**PROJECT** *(Name and Address)*  
EAST HEIGHTS ELEMENTARY SCHOOL RENOVATION  
1776 ADAMS LANE  
HENDERSON, KY 42420

**CHANGE ORDER NUMBER:** 14-1-2  
**INITIATION DATE:** 6/11/2025

Please provide a credit, including materials, labor and fees for the simplification of the ceiling design in the Media Center.

**Henderson County East Heights Elementary Renovation**  
**PR #05 05/28/2025**

Item #1 Refer to Sheet M2.23 – Air Distribution New Work Plan – Phase 2 – Area D

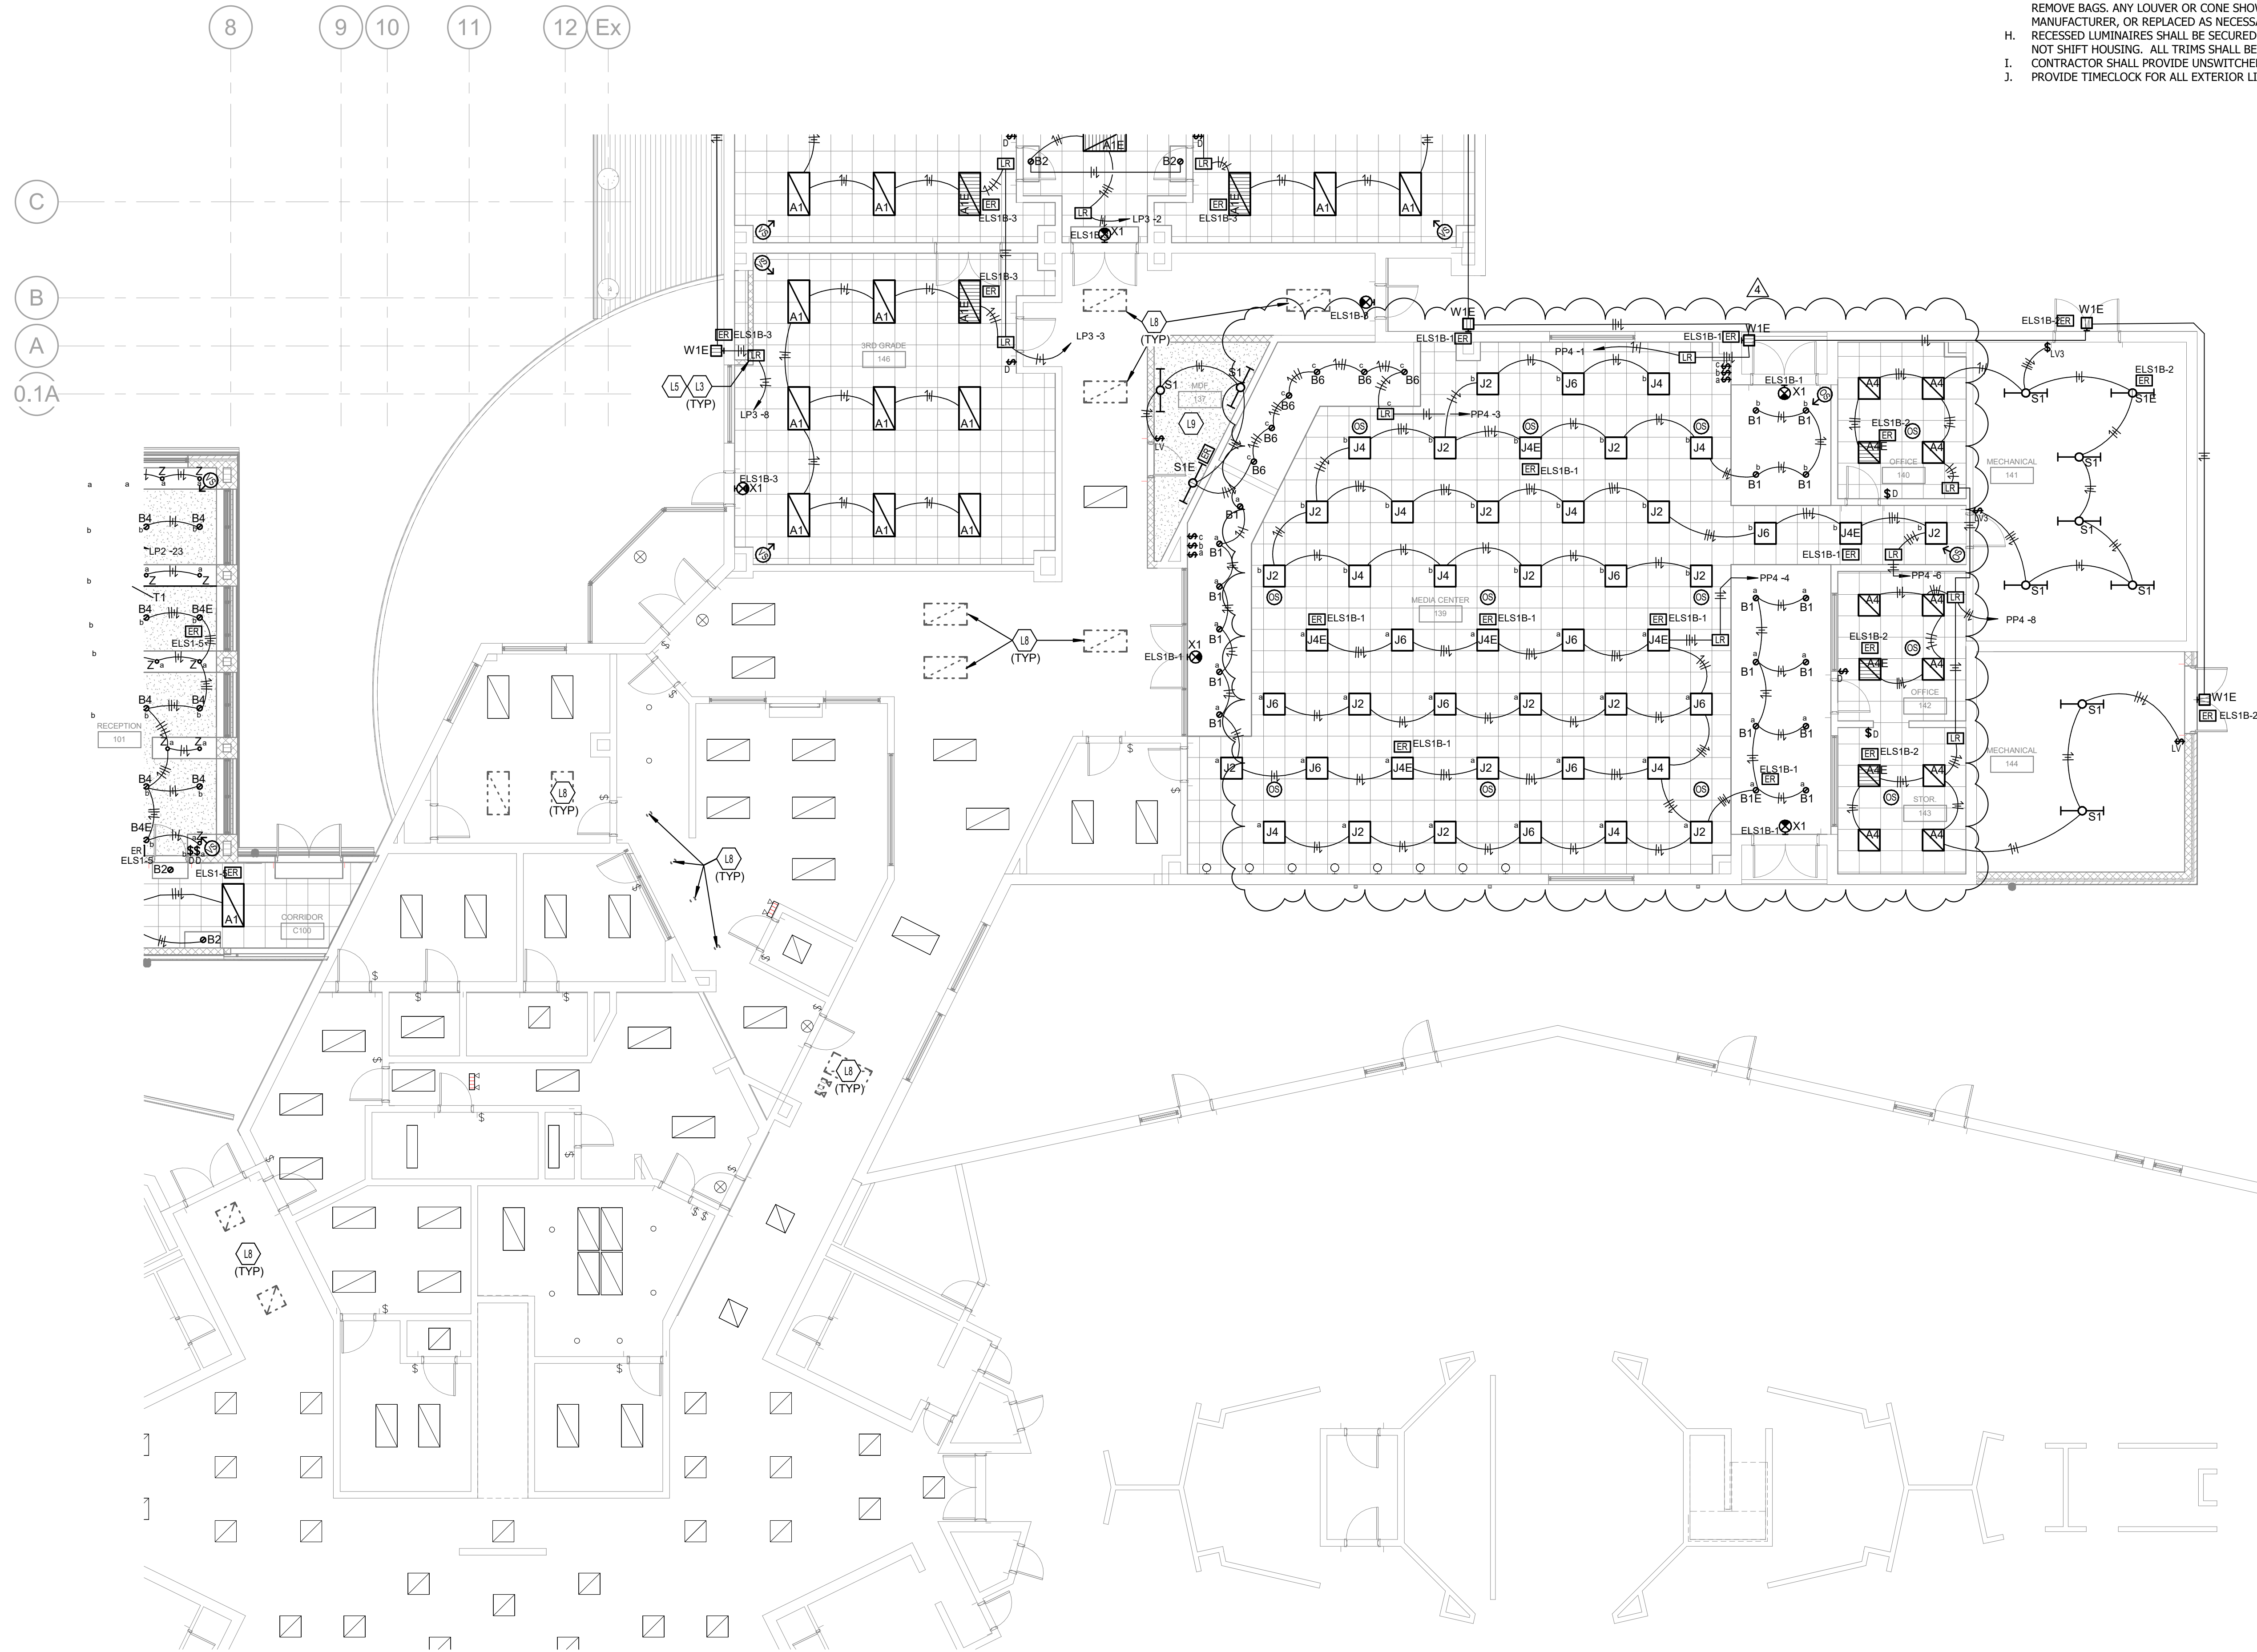
A. Modified diffuser layout accommodate ceiling change.

Refer to attached M2.23 for new diffuser layout.

NEW WORK LIGHTING PLAN - PHASE 2 - AREA D

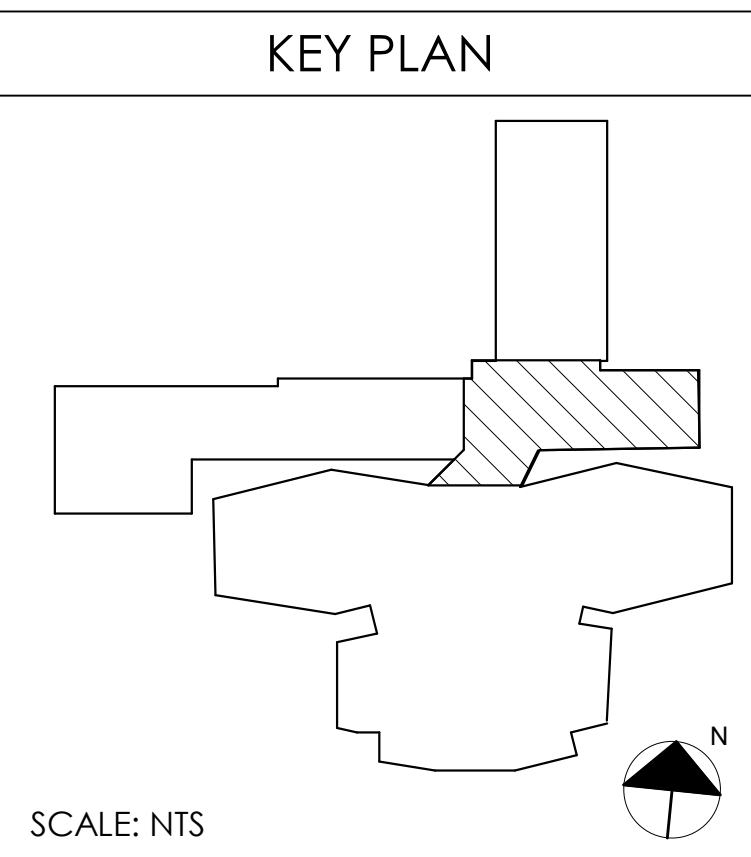
A. There were a total of six (6) Type B1 fixtures newly added to the Media Center space. Refer to home run pane-circuit number and update panel schedules as required.

Refer to attached E2.23 for new light fixture layout. 6 Type B1 fixtures have been added; refer to home run pane-circuit number and update panel schedules as required.
